# Transportation Staff Meeting

Subject: TCC Comments on Environmental Assessment for Consolidated TIP Projects  
I-3311C, I-5405, and I-4750(HOT)

SUBJECT: Response to Request for Comments, TIP Project I-5405

# I-77 Improvements and Non-Motorized Transportation Facilities

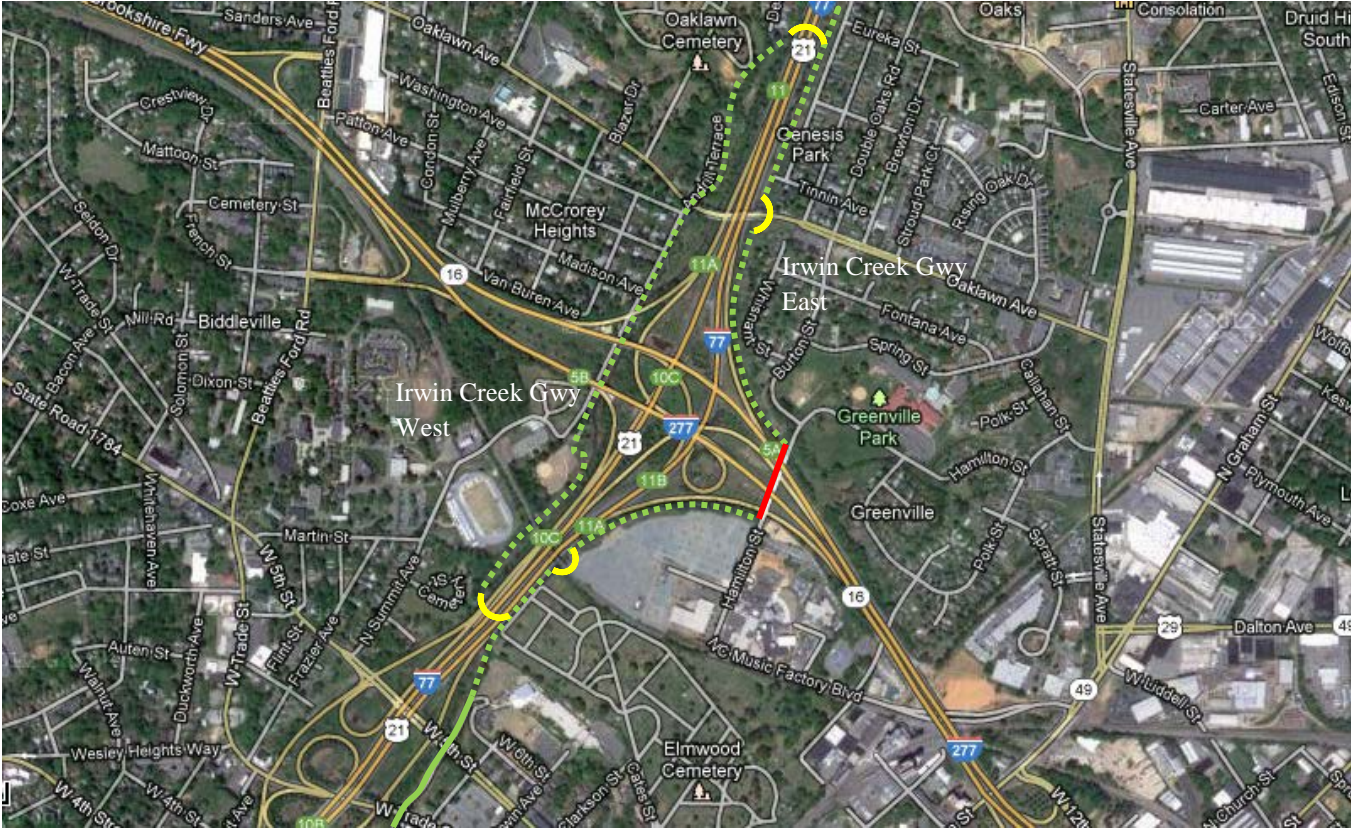
- Irwin Creek is located on both the east and west side of the I-77 corridor.
- Irwin East* connects BrightWalk, Anita Stroud Park, the NC Music Factory, and Ray's Splash Planet and therefore this route has a higher priority than *Irwin West*. The CSX Railroad bridge and Elmwood Cemetery are connectivity challenges for this route.
- Irwin West* connects Johnson C Smith University area to the uptown. This route may utilize the existing culvert. Use of the culvert is dependent on flood modeling and NCDOT permission.

- Irwin East* needs a grade-separated crossing under the east end of the Oaklawn Avenue bridge and bicycle and pedestrian accommodations the Oaklawn Avenue bridge. This trail will continue to Hamilton Road, the point access over I-277. After passing along the edge of the NC Music Factory parking, the trail must pass under the CSX rail and outboard of the Elmwood Cemetery. This route requires that the greenway trail be placed within the I-77 ROW. The trail will tie into existing Irwin Creek Greenway at Ray's Splash Planet, north of West 5<sup>th</sup> Street.
